TOWN OF CARMEL
PLANNING BOARD

PLANNING BOARD AGENDA
SEPTEMBER 14, 2016
MEETING ROOM #2

Stonefield Engineering & Design, LLC is pleased to submit documents to address the comments contained within the Town Engineer's Review Letter dated July 11, 2016, the Town Planner's Review Letter dated July 13, 2016, and the Memorandum from the Director of Code Enforcement dated July 11, 2016. Please find the following items enclosed for review:

DRAWING: C-4

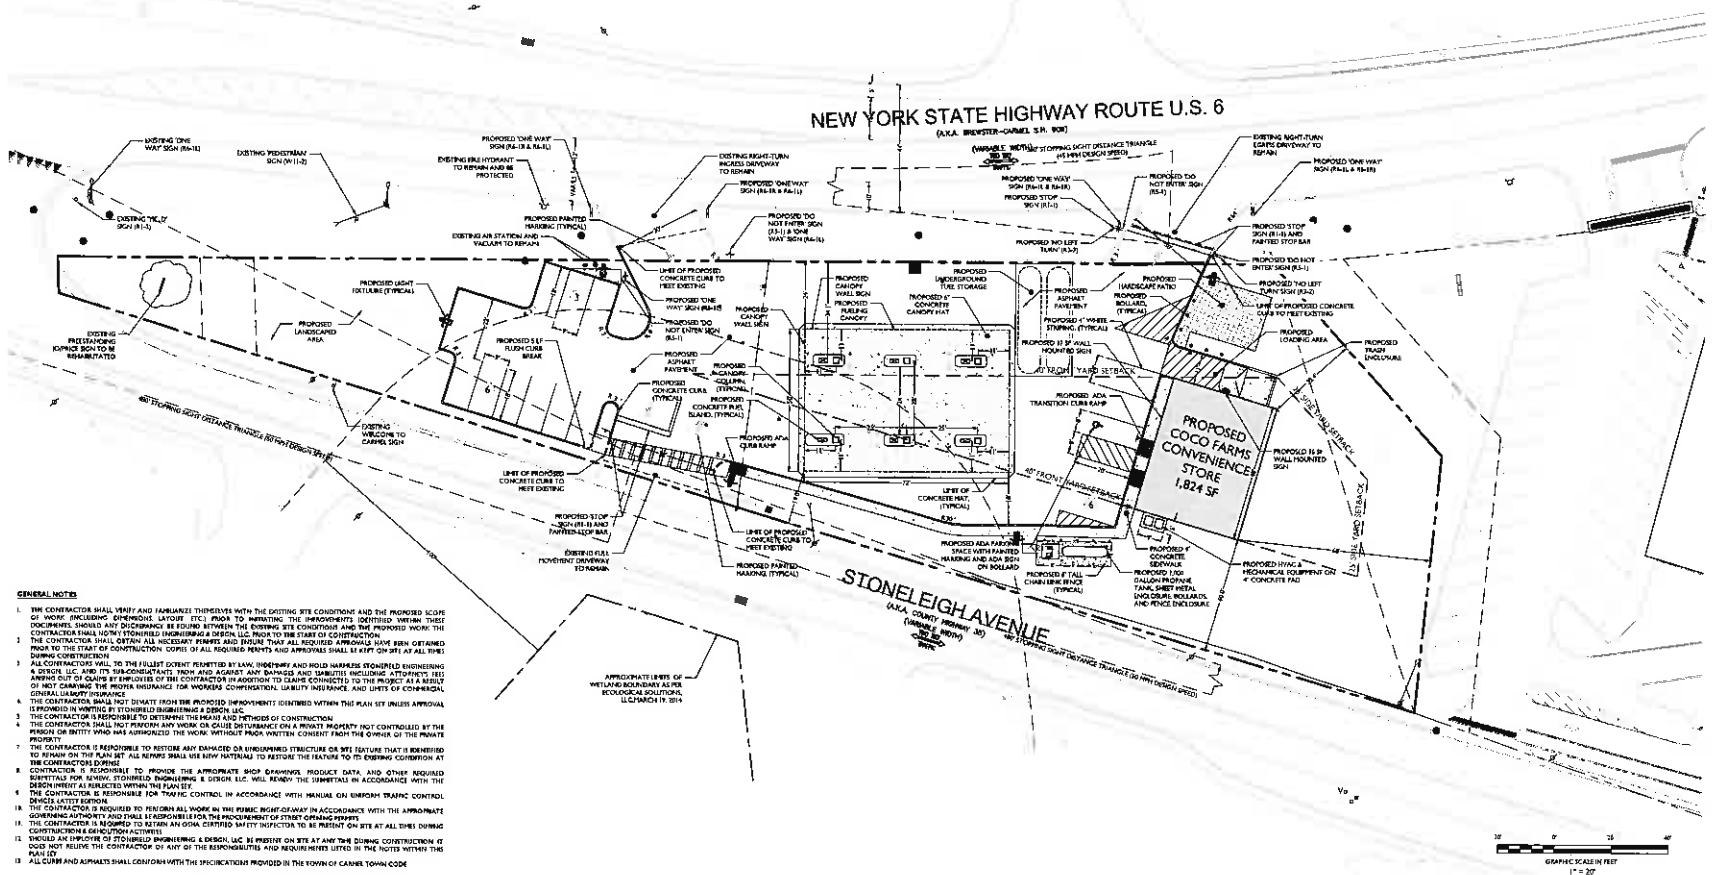
- b) *Available sight distances at each driveway location should be specified on plan. Any clearing along the edge of the roadway R.O.W. that may be necessary to assure appropriate sight distances are provided, should be identified. All calculations should be provided.*

- c) *Additional signage should be provided to help with traffic control at the site. This includes:*
- a. *Along the north entrance at Route 6 – do not enter signs (from the site onto Route 6).*
 - b. *Along the south east entrance at Route 6 – add a no left turn (from site onto Route 6)*
 - c. *Along the northwest exit/entrance along Stoneleigh Avenue – add no let turn (from site onto Stoneleigh)*

The Site Plan (Sheet C-4) has been updated to include the requested sight triangles.

The Site Plan (Sheet C-4) has been updated to include the “Do Not Enter” and “No Left Turn” signs along Route 6. Left-turn egress onto Stoneleigh Avenue is not proposed to be restricted. The Traffic Impact Study submitted for the application demonstrates that this turning movement can be adequately accommodated. Further, placing such a restriction would force driver’s desires of traveling south to take a circuitous path along residential roadways along including Old Route 6, Hughson Road, and Kelly Road.

It is anticipated that two employees will work per shift. A note has been added to the Site Plan (Sheet C-4).

A propane tank sale facility is proposed by the southwest corner of the proposed convenience store. The Site Plan (Sheet C-4) has been updated accordingly.

STONEFIELD
engineering & design, llc
SCALE: 1"=10' PROJECT NO: T41986
TITLE: GRADING & DRAINAGE PLAN
DRAWING: C-5

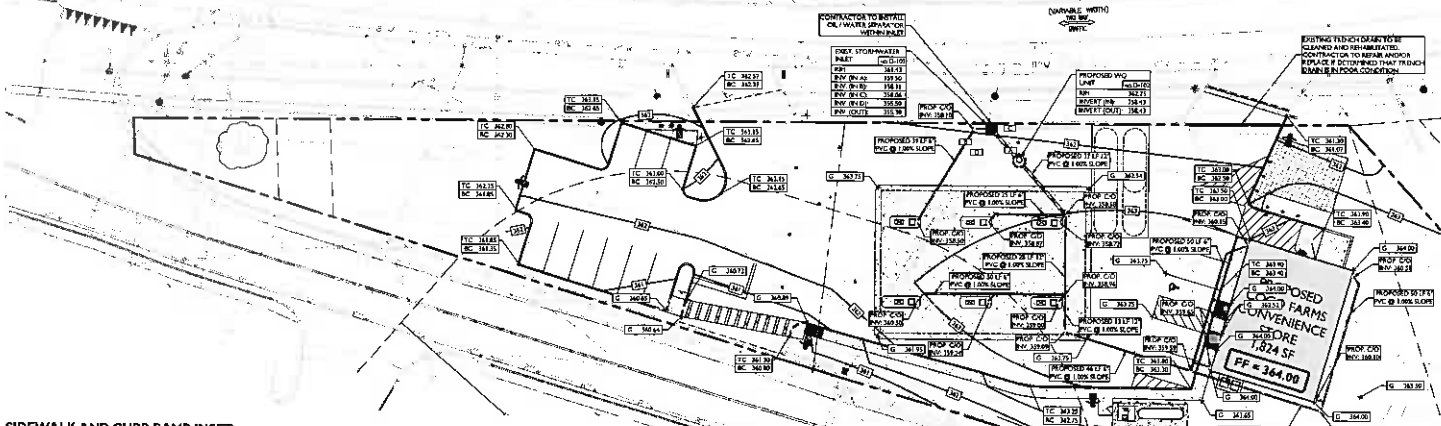
8. *All re-grading required to accomplish the intended development should be provided. This includes areas where trees are being planted outside of the limit of disturbance.*

The Grading & Drainage Plan (Sheet C-5) has been updated to include the requested information.

As the existing topography of the driveways is to remain, the trench drain is needed in order to collect all of the runoff. A note has been added to the Grading & Drainage Plan (Sheet C-5) to clean the trench drain and repair or replace as required.

The Grading & Drainage Plan (Sheet C-5) has been updated to include the proposed drainage design for the canopy.

The Grading & Drainage Plan (Sheet C-5) has been updated to include the roof leader connection locations.
